Loss from TP0 to TP2

P802.3ck Draft 3.1 comments 41, 43

Piers Dawe, Nvidia

April 2022

TP0-TP2 with range of max-loss host channels and current mated test fixtures

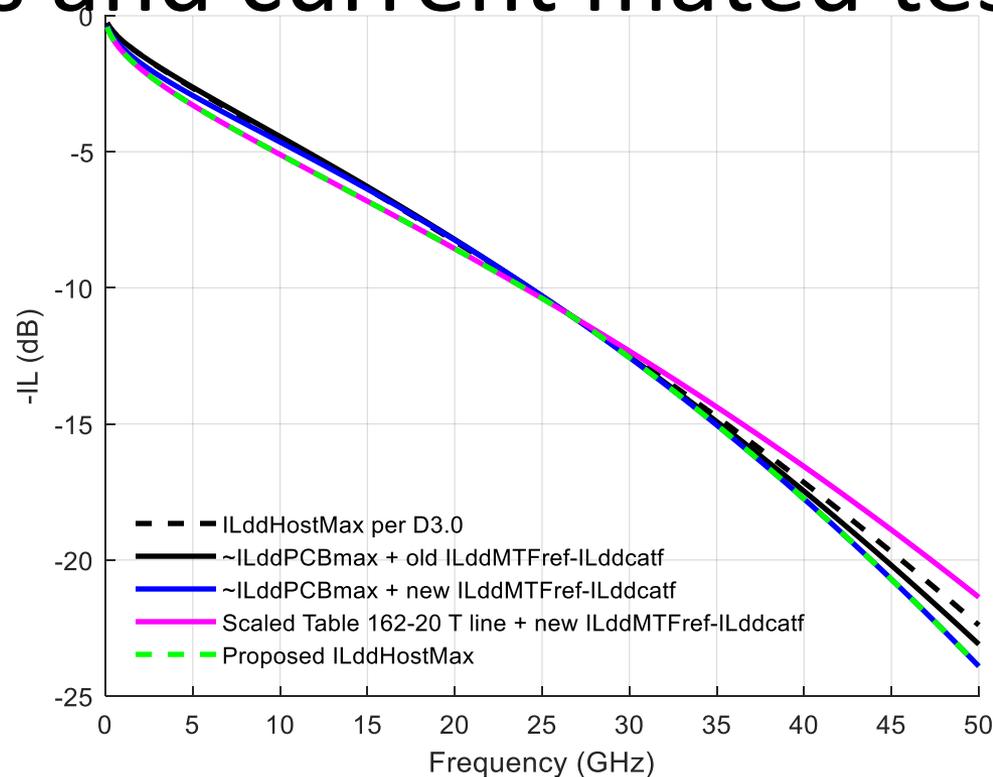
- Need to allow more curvature at low frequencies, but also roll-off well above Nyquist
- Recommend the magenta line below Nyquist and the blue above
 - A channel that rolls off more strongly than blue above ~35 GHz would work too
- Combination is shown as dashed green

Summary, new plot for Fig 162A–2

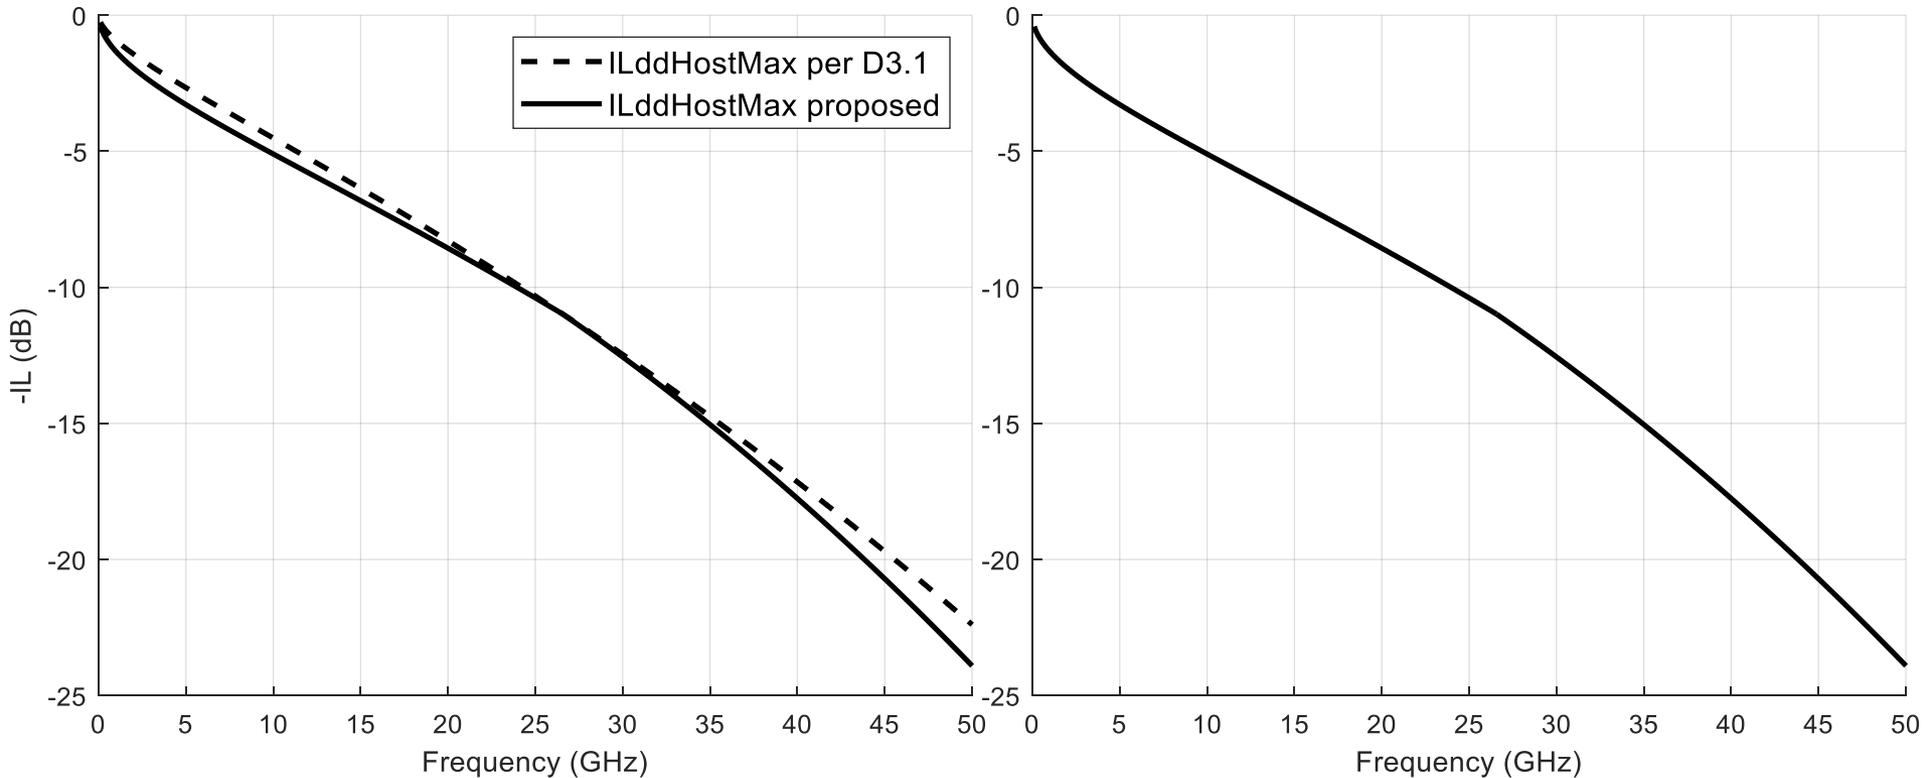
- Figure 162A–2 Insertion loss from TP0 to TP2 or from TP3 to TP5

Associated changes

- Equation 162A–3
 - Existing: $ILdd_{Host} \leq ILdd_{HostMax} =$
 $1.5658*(0.471*\sqrt{f}) + 0.1194f + 0.002f^2$
 - Proposed: $ILdd_{Host} \leq ILdd_{HostMax} =$
 $1.2513*\sqrt{f} + 0.08007f + 0.003405f^2 \quad 0.01 \leq f \leq 26.56$
 $1.1351*\sqrt{f} + 0.05202f + 0.005310f^2 \quad 26.56 < f \leq 50$
- Recalculate *Rpeak* (min) based on the magenta line
 - Table 162-10
 - ISI affects *Rpeak* too, so can't use the smooth curves: have to go back to more realistic models with ISI
 - Existing: 0.397
 - Proposed: 0.365
